ANSTY GARDEN COMMUNITY,

DESIGNERS RESPONSE

REPORT REF NO. 2207280-R18

Road Safety Audit Stage 1
Land at Ansty Farm
Proposed Highway Improvements
London Road / Whitemans Green
Cuckfield
West Sussex

Drawing Number **2207280-002** Rev **A**

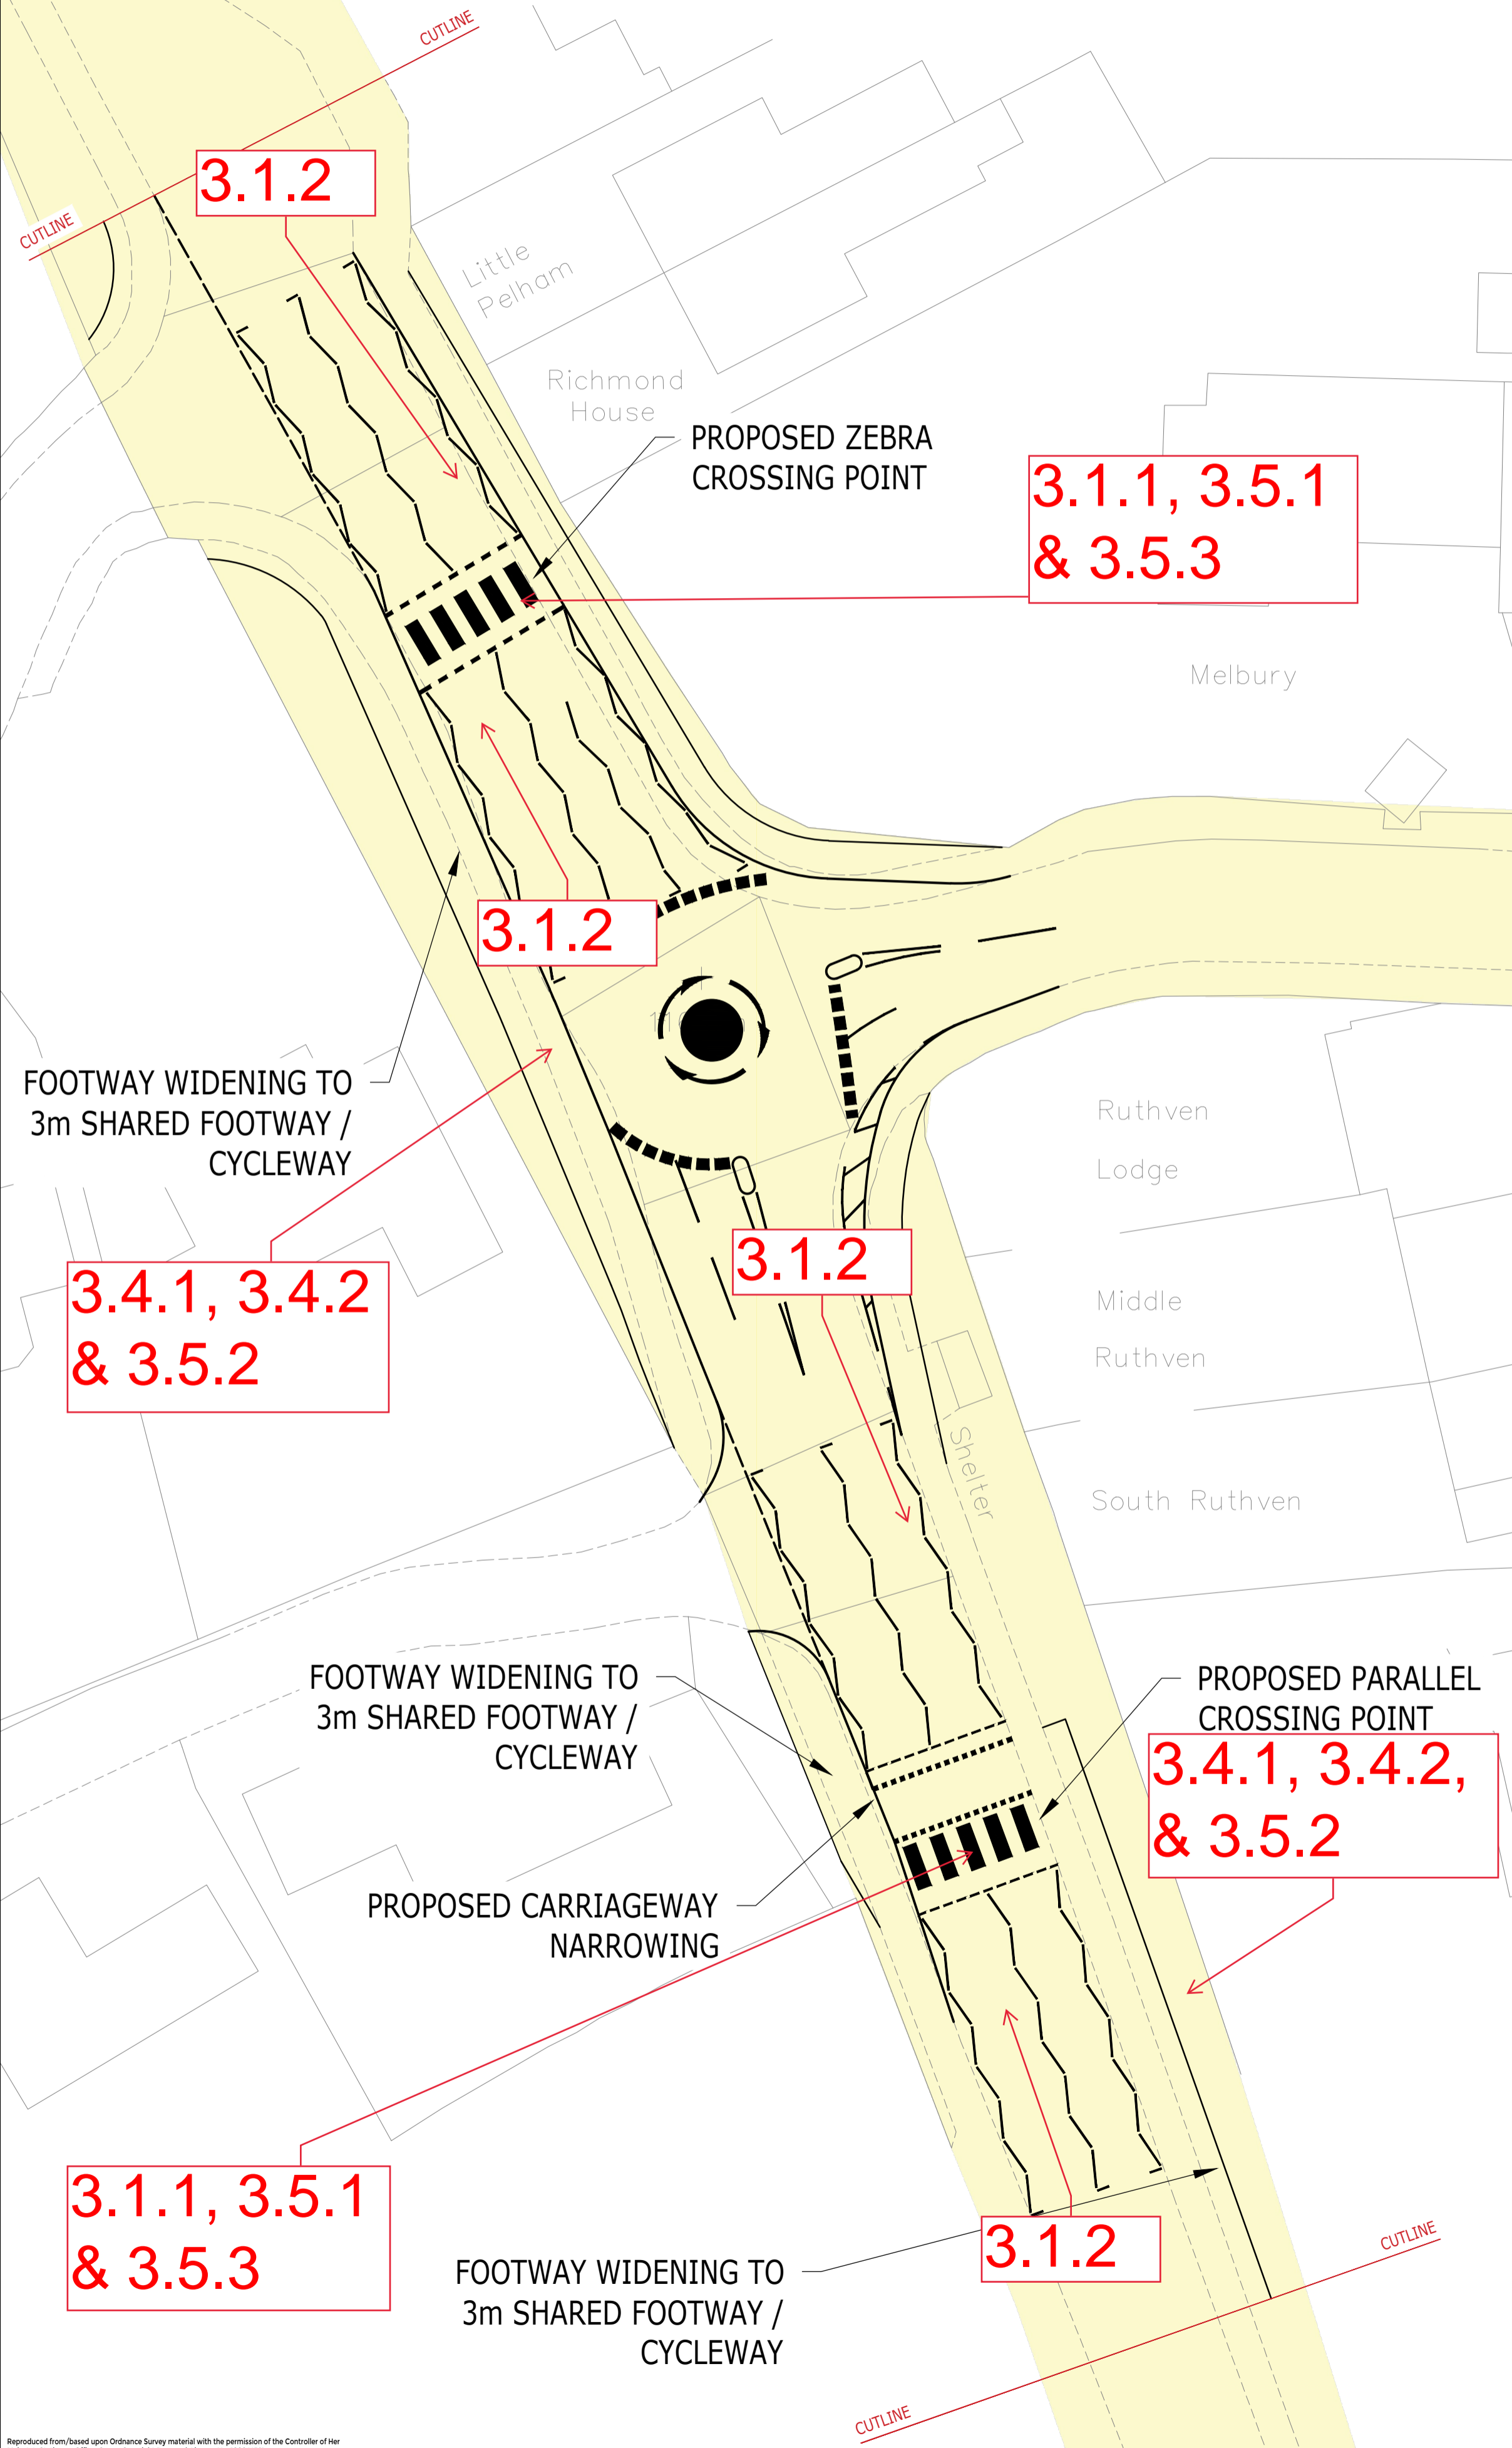
Summary: Irregular usage of the crossings could lead to vehicle to pedestrian / cyclist collisions or rear end shunts.

From observations on site there appears limited demand for these crossing facilities. Lack of usage of a controlled crossing can lead to drivers continually seeing no one using the crossing, then being surprised when a pedestrian or cyclist uses the crossing. This could lead to vehicle to pedestrian / cyclist collisions, or sudden braking and rear end shunts.

It is recommended that surveys should be undertaken to establish a sufficient degree of usage or future usage, for the proposed crossings. Should there be a lack of usage then alternative crossing facilities should be examined.

The proposals do not include the introduction of anti-skid surfacing or a surface with a high polished stone value (PSV) on the approaches to the crossings. Surfacing with an inadequate PSV could lead to vehicles not being able to stop, leading to possible rear end shunt or vehicle to pedestrian / cyclist collisions.

It is recommended that antiskid surfacing or surfacing with a high PSV should be used on the approaches to the crossings.

Shared use footway / cycleways are proposed; however, no details have been supplied on how cyclists will gain access to the on carriageway or if the shared routes continue. It is unlikely that cyclists will dismount, rather they will continue to ride on the footway, which could lead to cyclist to pedestrian collisions.

It is recommended that details should be supplied on how the shared use route will tie into the carriageway.

Shared footway / cycleway are proposed; however, at this early stage, no details have been provided on the tactile paving. Pedestrians may be unaware that the footway is a shared use route, which may lead to cyclist to pedestrian collisions.

It is recommended that paving details are provided are provided for assessment at Stage 2 Safety Audit.

At this early stage, no street lighting is proposed at the crossings, where the existing lighting system appears to be limited and may not be sufficient for the crossings. Pedestrians and cyclists could attempt to cross and suddenly appear from the dark area without, which could lead to vehicle to pedestrian / cyclist collisions.

It is recommended that there should be adequate levels of luminance where a check should be undertaken with Highway Authority Street Lighting Team.

Shared footway / cycleways are proposed; however, at this early stage, no details have been provided on the vertical signage. Pedestrians may be unaware that the footway is a shared use route, which may lead to cyclist to pedestrian collisions.

It is recommended that signing details are provided are provided for assessment at Stage 2 Safety Audit.

The Give Way lines appear too close to the stud lines at the Zebra crossing. This may cause vehicles to stop close to the crossing, reducing the intervisibility with pedestrians who are using crossing, particularly child pedestrians, which could lead to pedestrian or rear end shunt accidents.

It is recommended that the 'Give Way' markings should be set back a minimum of 2.5m from the stud lines.

RSA problem	RSA recommendation	Design Organisation response	Overseeing Organisation response	Agreed RSA action
<p>3.1.1 Irregular usage of the crossings could lead to vehicle to pedestrian / cyclist collisions or rear end shunts.</p> <p>From observations on site there appears limited demand for these crossing facilities. Lack of usage of a controlled crossing can lead to drivers continually seeing no one using the crossing, then being surprised when a pedestrian or cyclist uses the crossing. This could lead to vehicle to pedestrian / cyclist collisions, or sudden braking and rear end shunts.</p>	<p>It is recommended that surveys should be undertaken to establish a sufficient degree of usage or future usage, for the proposed crossings. Should there be a lack of usage then alternative crossing facilities should be examined.</p>	<p>The proposed crossings have been designed in accordance with relevant guidance and standards to ensure potential pedestrian use of the proposed facilities is clearly visible to other road users.</p> <p>As part of Active Travel Guidance pedestrian and cycle facilities are proposed to encourage other modes of transport in line with WSCC consultation feedback, and are designed in order to encourage increased use compared to current levels.</p> <p>There are also schools in the vicinity and parents/pupils would make use of the facilities, which would result in an increased demand outside of the hours observed</p>

by the Audit team during their visit.		
<p>3.1.2 Inappropriate surfacing could lead to vehicle to pedestrian / cyclist collisions or rear end shunts.</p> <p>The proposals do not include the introduction of anti-skid surfacing or a surface with a high polished stone value (PSV) on the approaches to the crossings. Surfacing with an inadequate PSV could lead to vehicles not being able to stop, leading to possible rear end shunt or vehicle to pedestrian / cyclist collisions.</p>	<p>It is recommended that antiskid surfacing or surfacing with a high PSV should be used on the approaches to the crossings.</p>	<p>Details of PSV values and surfacing materials will be provided for Stage 2 Audit.</p>		
<p>3.4.1 Lack of connectivity could lead to cyclist to pedestrian collisions.</p> <p>Shared use footway / cycleways are proposed; however, no details have been supplied on how cyclists will gain access to the on carriageway or if the shared routes continue. It is unlikely that cyclists will dismount, rather they will continue to ride on the footway, which could lead to cyclist to pedestrian collisions.</p>	<p>It is recommended that details should be supplied on how the shared use route will tie into the carriageway.</p>	<p>Proposed cycle 'scoops' and dropped kerbs have been shown on ACE Drawing 2207280-002B with appropriate road markings to guide cyclists to and from the proposed shared foot/cycleway facility. The southern crossing design has been amended to a zebra to refine the connectivity for cyclists and simplify the arrangements. Corduroy paving to warn cyclists of the pedestrian footway have also been shown.</p>

<p>It is also noted on the drawing that appropriate signage will be provided as per LTN 1/20 & TSRGD standards.</p>		
<p>3.4.2 Absence of tactile paving could lead to cyclist to pedestrian collisions.</p> <p>Shared footway / cycleway are proposed; however, at this early stage, no details have been provided on the tactile paving. Pedestrians may be unaware that the footway is a shared use route, which may lead to cyclist to pedestrian collisions.</p>	<p>It is recommended that paving details are provided are provided for assessment at Stage 2 Safety Audit.</p>	<p>The design proposals have been refined in this location and proposed tactile and corduroy paving have been shown on ACE Drawing 2207280-002B. Further details will also be provided for Stage 2 Audit.</p>		
<p>3.5.1 A lack of luminance could lead to vehicle to pedestrian / cyclist collisions.</p> <p>At this early stage, no street lighting is proposed at the crossings, where the existing lighting system appears to be limited and may not be sufficient for the crossings. Pedestrians and cyclists could attempt to cross and suddenly appear from the dark area without, which could lead to vehicle to pedestrian / cyclist collisions.</p>	<p>It is recommended that there should be adequate levels of luminance where a check should be undertaken with Highway Authority Street Lighting Team.</p>	<p>It has been noted on ACE Drawing 2207280-002B that street lighting is to be considered in liaison with WSCC as per the recommendation. Lighting details to be provided for Stage 2 Audit.</p>

<p>3.5.2 Absence of vertical cyclist signage could lead to cyclist to pedestrian collisions.</p> <p>Shared footway / cycleways are proposed; however, at this early stage, no details have been provided on the vertical signage. Pedestrians may be unaware that the footway is a shared use route, which may lead to cyclist to pedestrian collisions.</p>	<p>It is recommended that signing details are provided for assessment at Stage 2 Safety Audit.</p>	<p>Signage details will be provided for Stage 2 Audit.</p>		
<p>3.5.3 Positioning of Give Way lines could lead to vehicle to pedestrian collisions.</p> <p>The Give Way lines appear too close to the stud lines at the Zebra crossing. This may cause vehicles to stop close to the crossing, reducing the intervisibility with pedestrians who are using crossing, particularly child pedestrians, which could lead to pedestrian or rear end shunt accidents</p>	<p>It is recommended that the 'Give Way' markings should be set back a minimum of 2.5m from the stud lines.</p>	<p>The proposed road markings for the zebra crossings have been updated as per safety audit recommendations and TSRGD standards. These are shown on ACE Drawing 2207280-002B.</p>

3.1.1 – Noted and accepted.
3.1.2 – Noted and accepted.
3.4.1 – Noted and accepted.
3.4.2 – Noted and accepted.
3.5.1 – Noted and accepted.
3.5.2 – Noted and accepted.
3.5.3 – Noted and accepted.
